APPEAL SUMMARY

Appeal ID: 32300	Project Address: 13132 SE Ramona St
Hearing Date: 5/22/24	Appellant Name: Whitney Ruckel
Case No.: B-008	Appellant Phone: 503-925-5298
Appeal Type: Building	Plans Examiner/Inspector: John Cooley
Project Type: Commercial	Stories: 1 Occupancy: E & S-2 (with A & B accessory) Construction Type: V-B
Building/Business Name: Gilbert Park Elementary School	Fire Sprinklers: Yes - Corridors (Standard Q, Option 2)
Appeal Involves: Erection of a new structure	LUR or Permit Application No.: 24-011442-CO
Plan Submitted Option: pdf [File 1]	Proposed use: Bike Shelter

BUILDING IMPROVEMENTS
DAVID DOUGLAS SCHOOL DISTRICT
GILBERT PARK ELEMENTARY SCHOOL
13132 SE RAMONA ST, PORTLAND, OR 97236

A-102.1

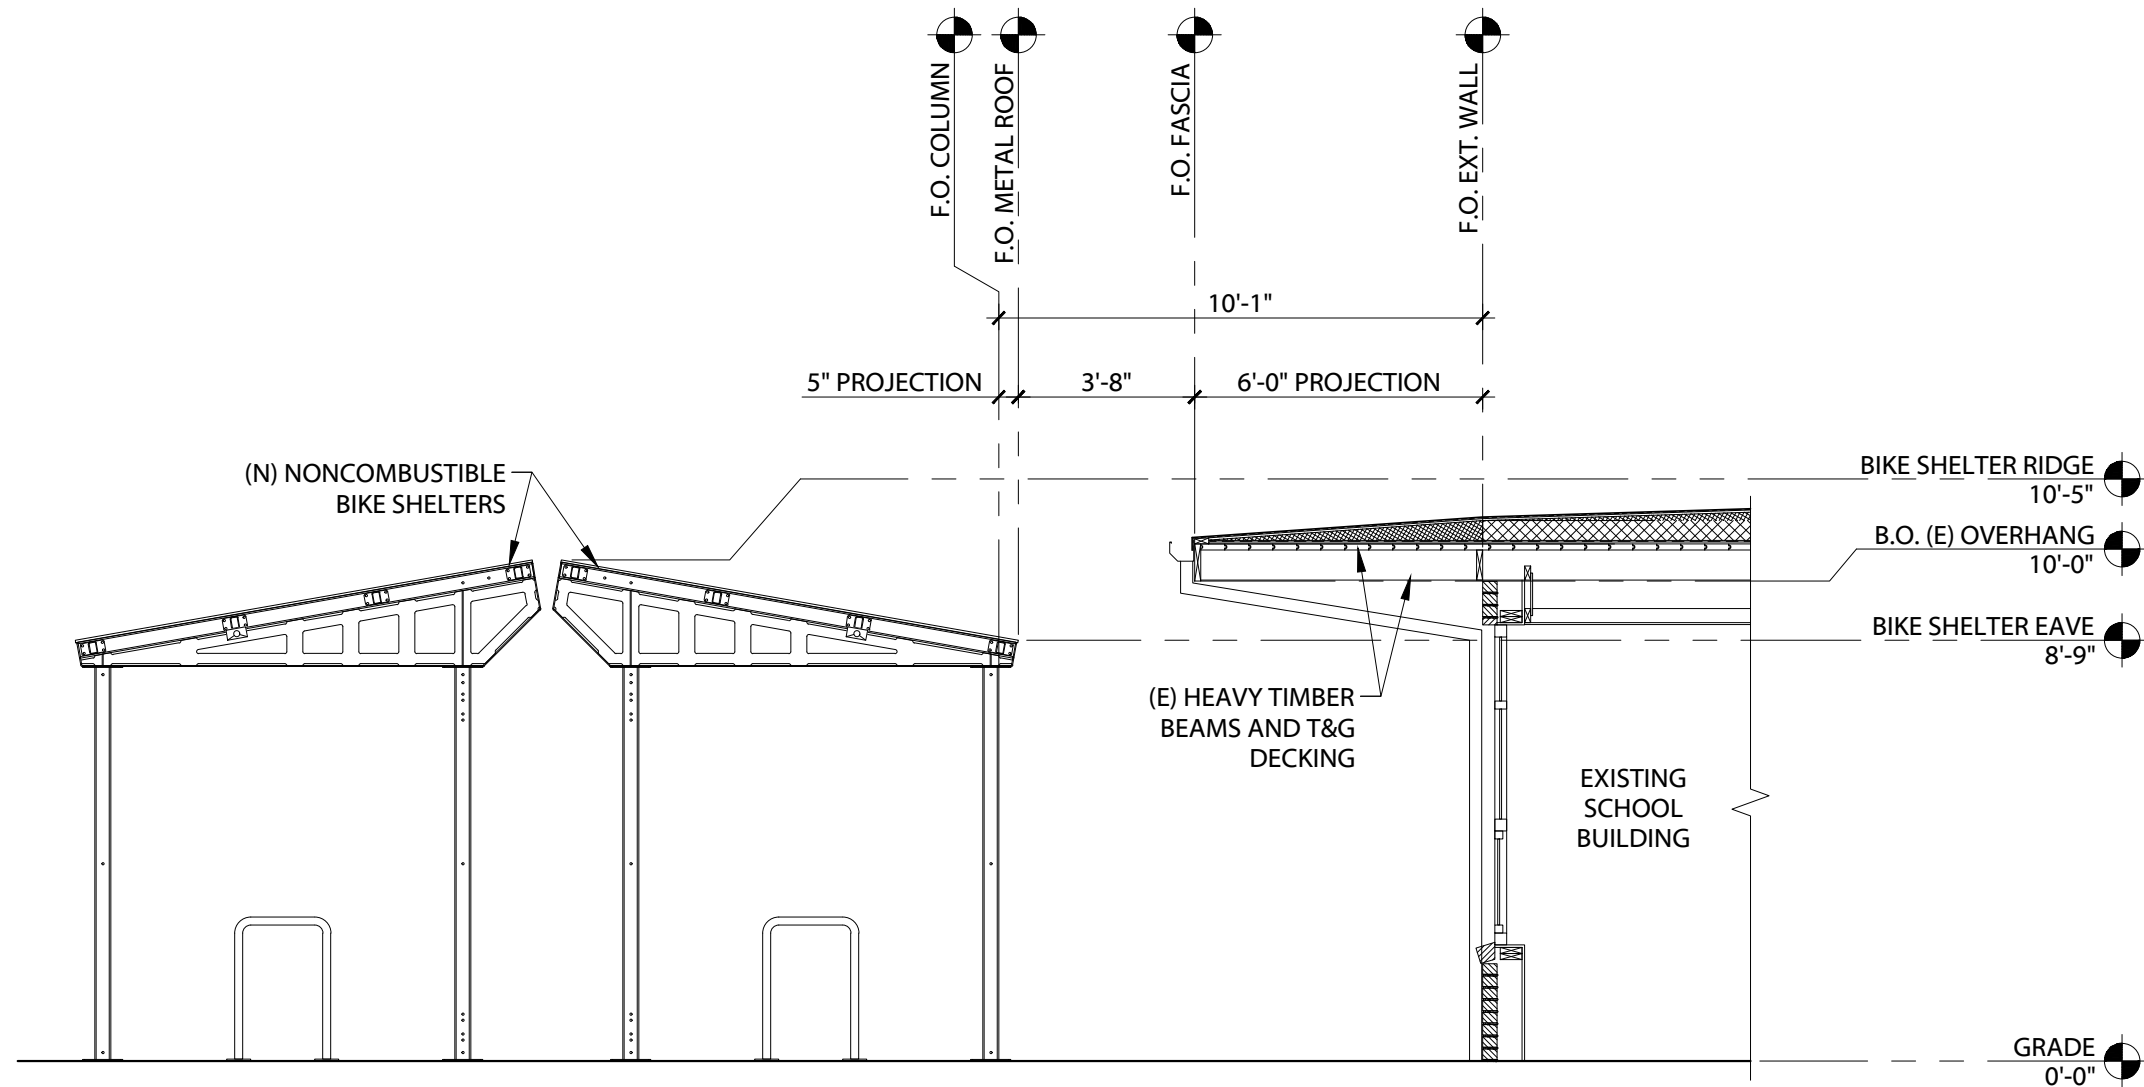
Code Section	OSSC 705.2 & 705.5
Requires	Table 705.2 puts limitations on projections beyond exterior walls. Table 705.5 requires exterior walls be rated based on their occupancy type, construction type, and fire-separation distance.
Code Modification or Alternate Requested	Due to allowable area limitations, we are proposing the bike shelters be a separate building from the existing school buildings. Section 33.266.210.D.1.a.(5) of the Portland Zoning Code requires long-term bike parking spaces for schools be located within 100' of the main entrance. Because of site constraints, we are seeking to keep the bike shelters where they are currently shown on the plans. We're seeking an appeal for the required fire separation distance necessary to have non-rated walls.
Proposed Design	Where our bike shelters are currently shown on the plans, there is a 10'-1" separation on the south side and a 23'-11" separation on the east side. These dimensions are taken from the exterior walls of the school to the columns of the bike shelters. The school's existing roof projects 6'-0" toward the bike shelter's south side, and 16'-0" toward the bike shelter's east side. The existing roof overhangs are made of heavy timber beams &

heavy timber tongue-and-groove decking, which reduces the fire risk. (Refer to attached sheet A-102.1 for dimensioned building sections at the bike shelters.)

Land use requires us provide covered & paved, long-term bike parking spaces that are within 100' of a main entrance. The proposed location is a safe & accessible location for the students to access the bikes and is within sight lines of school staff for security. The bikes that would be parked are a low hazard, and the bike shelters are noncombustible. A portable fire extinguisher is provided next to the entry vestibule.

Reduced fire separation distance for non-combustible open air bike shelter: Granted as proposed.
